# Access Compliance Report

### (Curb Ramps)

Intersection ID: 17966	Main Street: GAYNOR_RD	Cross Street: HARDWICK_RD	Location: NW
ADA ID: 153CA83F107F	Ramp Type: PerpDiag	Initial Pass/Fail: Fail	Overall Compliance: No
Codes/Mitigation Info/Possible Solution		Field Measurements/Component Compliance

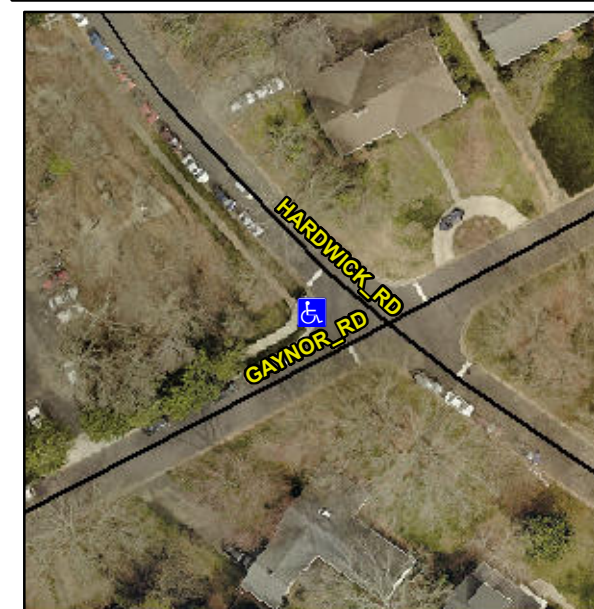
**Not Found, R304.5.3**

Compliance	Description	Data	Compliance	Description	Data
N/A	Ramp Length (in)	65.0	Yes	Ramp Slope (%)	7.4
Yes	Ramp Width (in)	137.0	No	Ramp XSlope (%)	4.0
N/A	Flare Type LT	N/A	N/A	Flare Type RT	N/A
N/A	Flare Slope LT (%)	N/A	N/A	Flare Slope RT (%)	N/A
N/A	Flare Traversable LT?	N/A	N/A	Flare Traversable RT?	N/A
N/A	Landing Length (in)	N/A	N/A	DWS Provided?	N/A
N/A	Landing Width (in)	N/A	N/A	DWS Contrast?	N/A
N/A	Landing Slope (%)	N/A	N/A	DWS Length (in)	N/A
N/A	Landing X Slope (%)	N/A	N/A	DWS Full Width?	N/A
N/A	Landing Curb? (Y/N)	N/A	N/A	DWS Offset (in)	N/A
N/A	Shared Landing?	N/A			
N/A	Gutter Ponding?	N/A	N/A	Gutter Slope (%)	N/A
N/A	Gutter Lip Ht (in)	N/A	N/A	Gutter X Slope (%)	N/A
N/A	Painted X Walk1?	No	N/A	Painted X Walk2?	No
	X Walk 1 Direction	To SE		X Walk 2 Direction	To NE
N/A	X Walk 1 Width (in)	N/A	N/A	X Walk 2 Width (in)	N/A
	X Walk 1 Slope (%)	0.8		X Walk 2 Slope (%)	2.5
	X Walk 1 X Slope (%)	1.7		X Walk 2 X Slope (%)	1.5

**Remove & Replace Curb Ramp With Two New Directional Ramps or Equivalent.**
